RE: 249 MADRAS STREET

SKETCH 3508/SK1

**STRUCTURAL REPORT**

**OFFICE BUILDING  
249 MADRAS STREET**

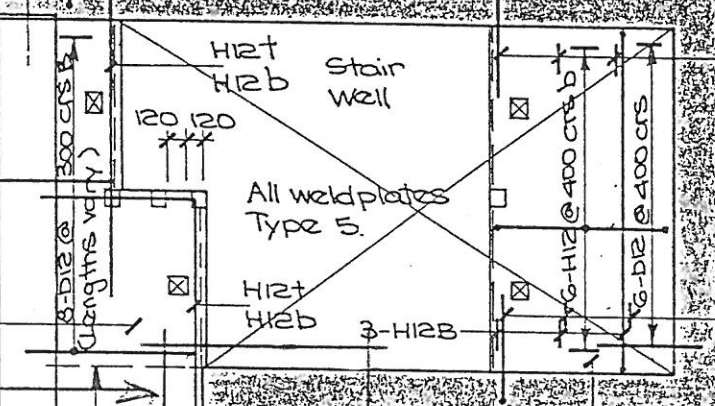
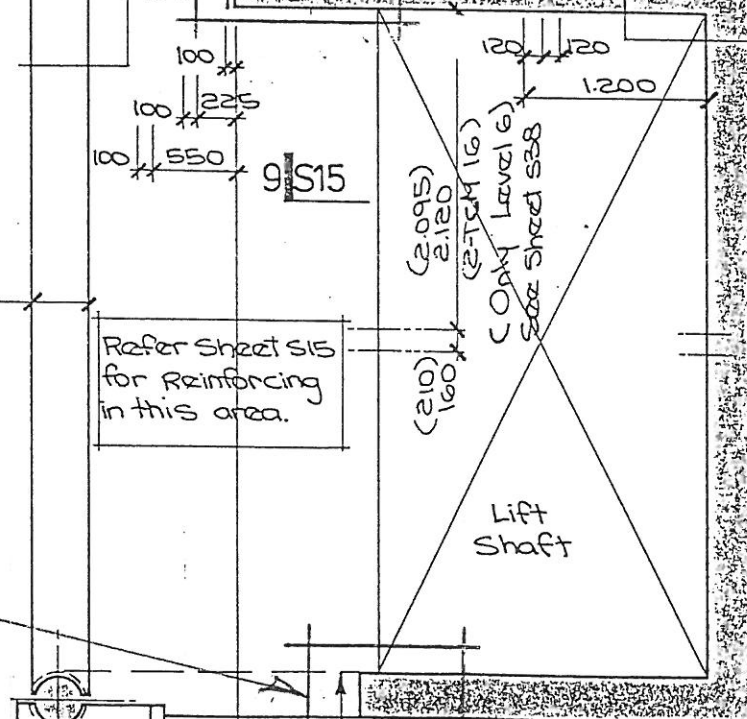
Further to our discussions by telephone this morning, we confirm that the scope of the possible non-compliance referred to in your report on the building is the connections between the walls on gridlines D and D/E, as shown on the attached sketch SK1 from levels 2 to 6 inclusive (Level 1 being the ground floor carpark).

The proposed remedial work, if required, would consist of a total of two ties per floor, tying the walls to the floor diaphragm.

The agreed maximum tie load is 300 kN per tie. We understand that this load would be reduced on lower floors in accordance with the "Parts and Portions" section of NZS 4203:1984.

Line D Wall Tie to slab here

Line D/E Wall Tie to slab here.

SKETCH 3608/SK1

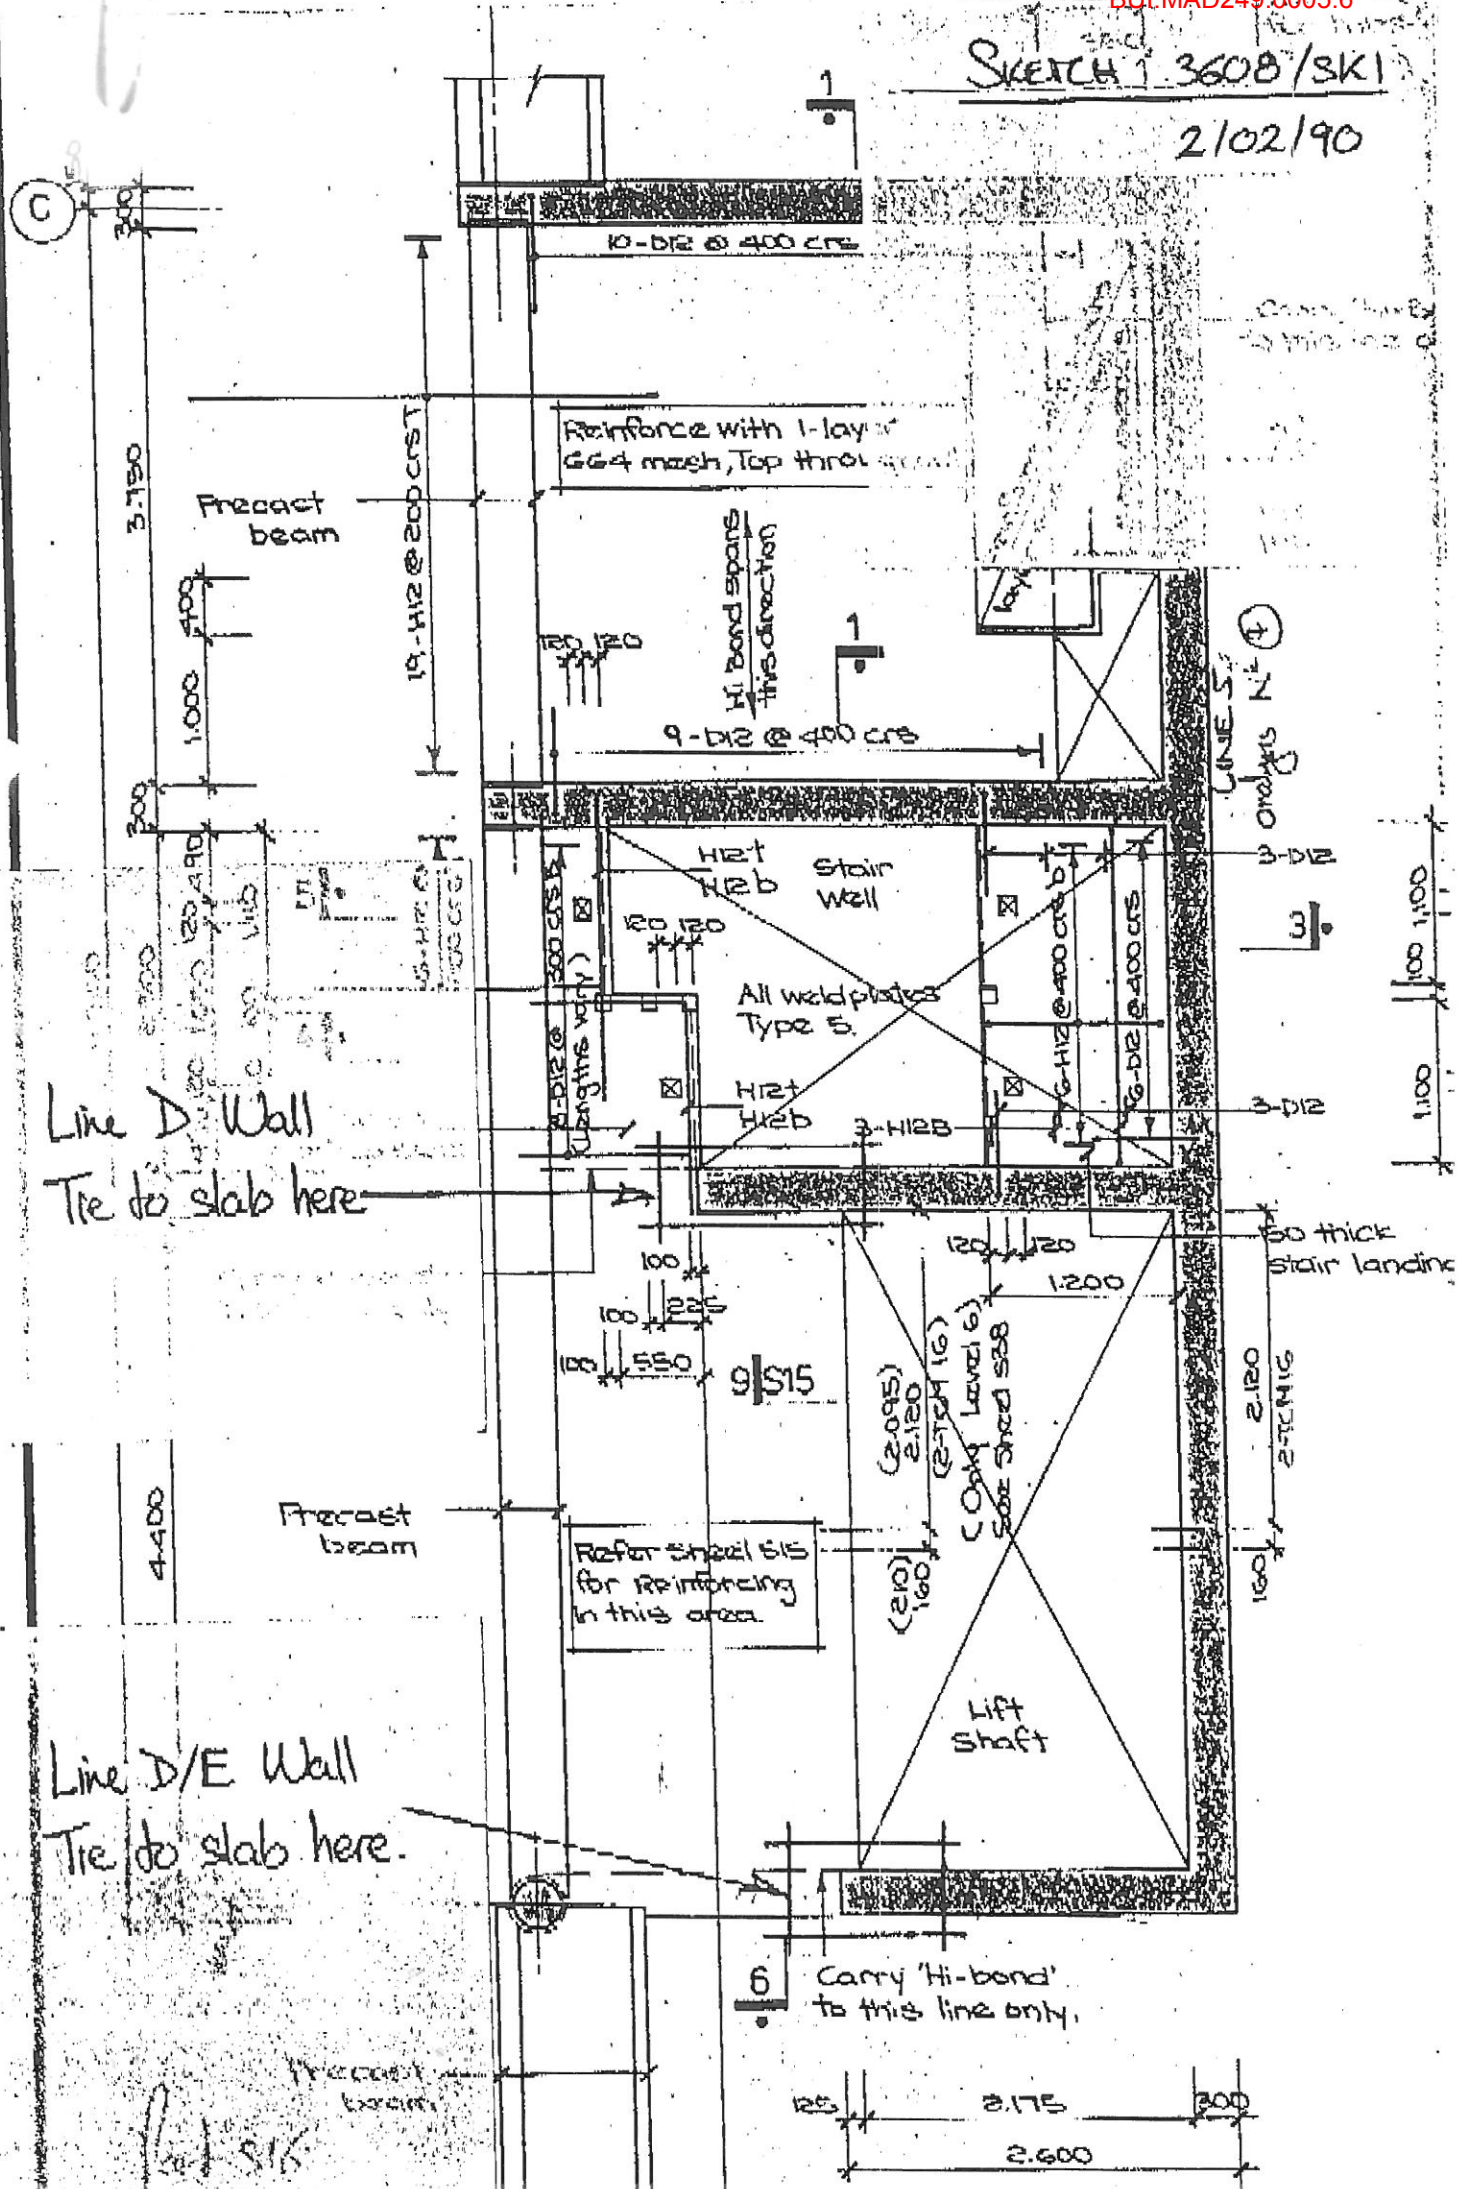
Further to our discussions by telephone this morning, we confirm that the scope of the possible non-compliance referred to in your report on the building is the connections between the walls on gridlines D and D/E, as shown on the attached sketch SK1 from levels 2 to 6 inclusive (Level 1 being the ground floor carpark).

The proposed remedial work, if required, would consist of a total of two ties per floor, tying the walls to the floor diaphragm.

The agreed maximum tie load is 300 kN per tie. We understand that this load would be reduced on lower floors in accordance with the "Parts and Portions" section of NZS 4203:1984.

PAGE Sk-01  
 DATE 31/1/20.

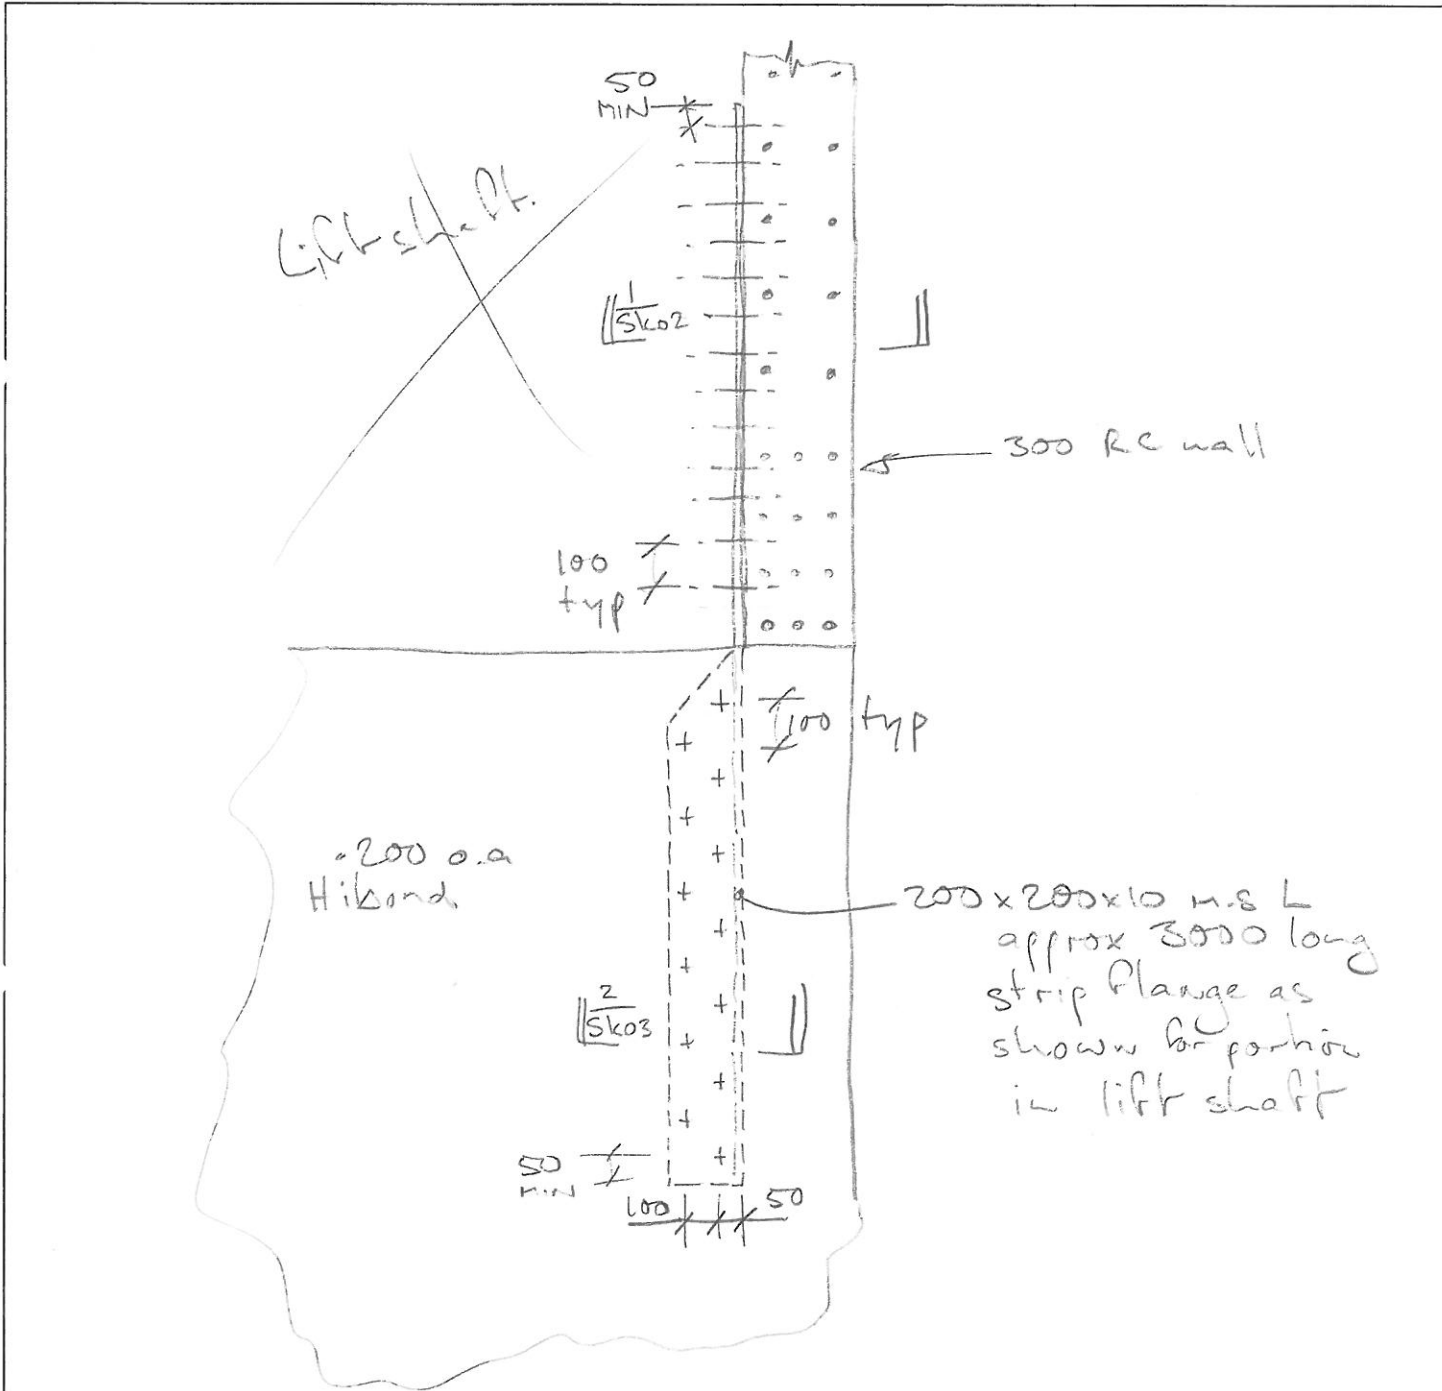
Remedial Works

Steel angle required.

2 per level at 5 levels.

- Require similar detail but handed at other side of lift shaft.
- Detail typical to levels 1 to 5.
- Reinstate all finishes when work completed eg ceilings, carpet.

Sk-02

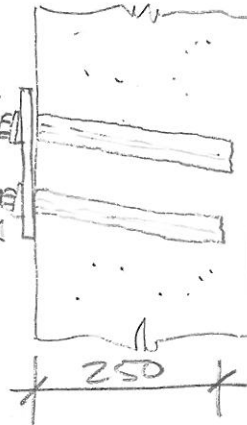
200x200x10 u-sL  
with flange removed  
over part  
of 13 or 14 studs

D12 threaded  
bars with tapered  
washers.

- Mark out & drill holes before cutting or drilling steel. Locate steel in wall prior to drilling holes.
- Holes in wall to be  $\phi$  drilled using percussive rotary drill. Epoxy bars using Expocrete 'S' or equivalent.

PAGE Sk-03

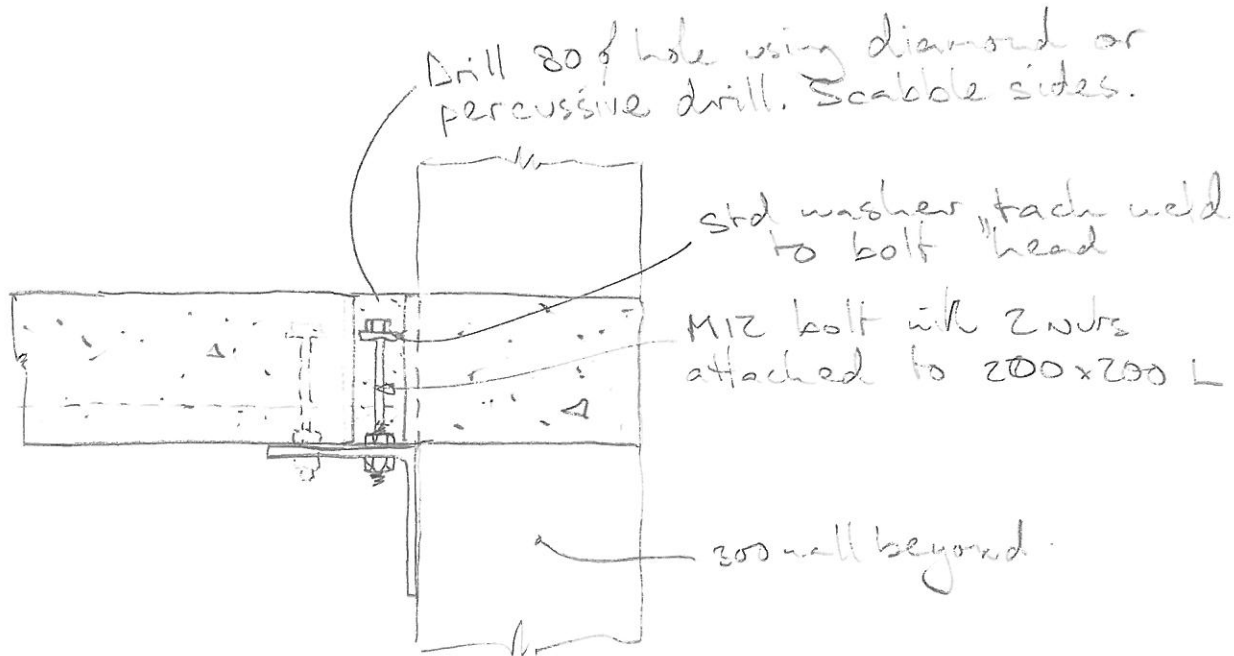
- Prior to drilling holes locate M12-200 bars top steel in slab. Confirm detail with engineer if any clash occurs.
- Mark out and drill holes through slab prior to cutting steel.
- After placing bolts, temporarily fix angle to underside of slab, and seal around gaps between Hibond ribs.
- Grout gap using Sika 212 or similar
